## Repositioning the patient outlet on the Tom Thumb infant resuscitator (all models)

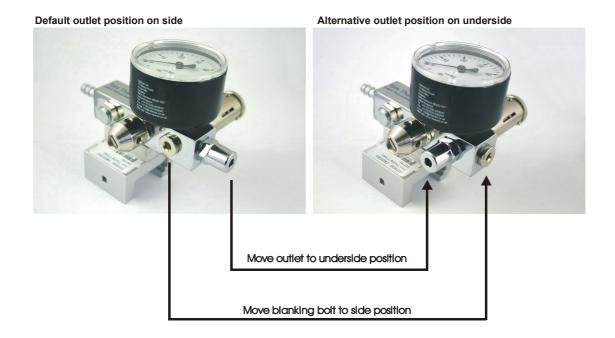
The Tom Thumb infant resuscitator can be modified so as to allow the patient circuit to connect to the underside of the Tom Thumb, rather than the default configuration on the side.

This involves removing the outlet and the underside blanking bolt nearest the outlet and swapping their positions.

Care should be taken to ensure that the O-rings attached to the outlet and the blanking bolt do not become damaged. Should replacement O-rings be required, they can be ordered from Viamed using part number 0330214.

Following any type of modification to the Tom Thumb, the device should be checked for accurate calibration. Service manuals are available from Viamed.
